CUP-19-11 (Purpose Built Student Housing)

Hold a public hearing and consider a request by 75 Sylvan Street for a Conditional Use Permit to allow a Purpose Built Student Oriented Housing development located on South Guadalupe Street between San Antonio Street and MLK Drive. (W. Parrish)

CUP-19-11 Recomended Additional Streetscape Improvements

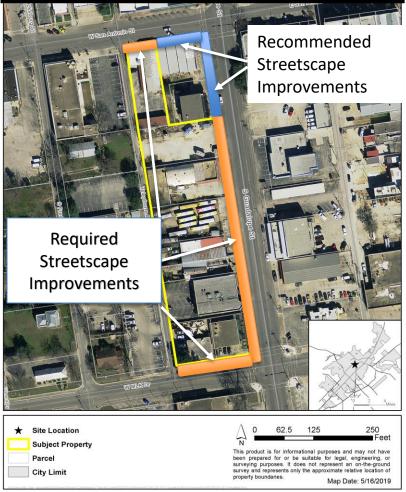
Planning Department Concerns

- Extended Streetscape Improvements;
- Noise from balconies facing neighborhoods;
- Conformance with Development Code standards.

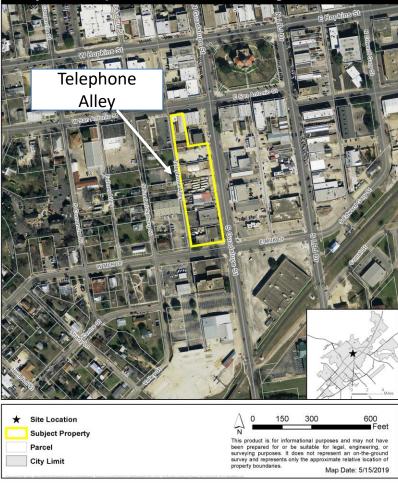
Engineering

- Alley width and access;
- The Pedestrian Passage alignment.

Public Services

- Alley width and access;
- All surrounding streets must be fully repaired after construction.
